**MANDATORY SERVICE BULLETIN NO. MSB 40NG-065 REV. 1**  
**SUPERSEDES MSB 40NG-065 REV. 0**

Type: DA 40 NG

Replacement of baggage nets with defective buckles.

Figure 1 - DA 40 NG baggage net installation.

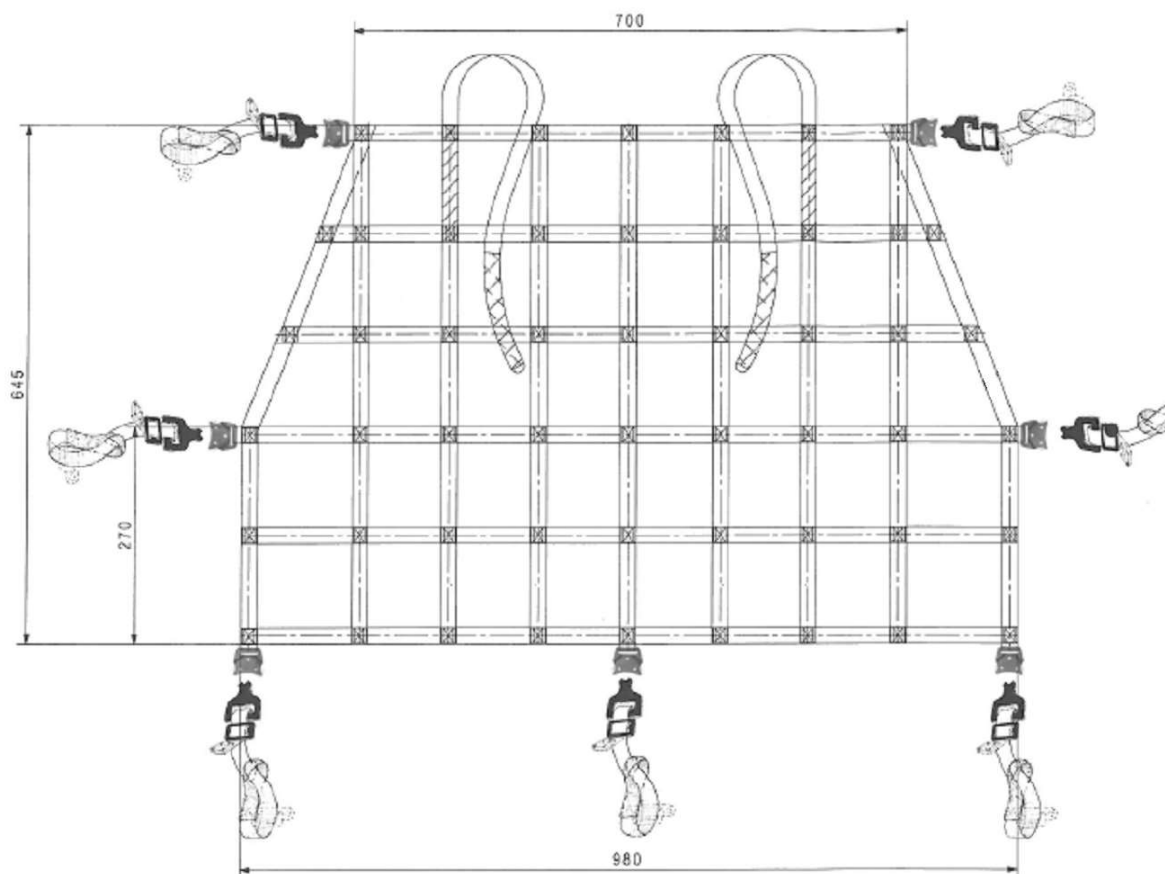
It has come to Diamond's attention that baggage nets with defective buckles have been installed on several aircraft due to a quality escape. These defective buckles may not maintain sufficient holding force and could pose a hazard to the passengers and crew. Effective immediately, these cargo nets are not to be used. Diamond will provide replacement nets to all those affected.

1. Refer to Section I.2. Identify if the baggage net in the aircraft is an affected net. Use the part number and date of manufacture to identify the net.
2. If an affected net is installed, clearly mark the currently installed net as defective, and remove it from the aircraft.

3. Destroy the removed baggage net, or return it to Diamond Aircraft Industries.
4. Install the new baggage net provided by Diamond Aircraft Industries.
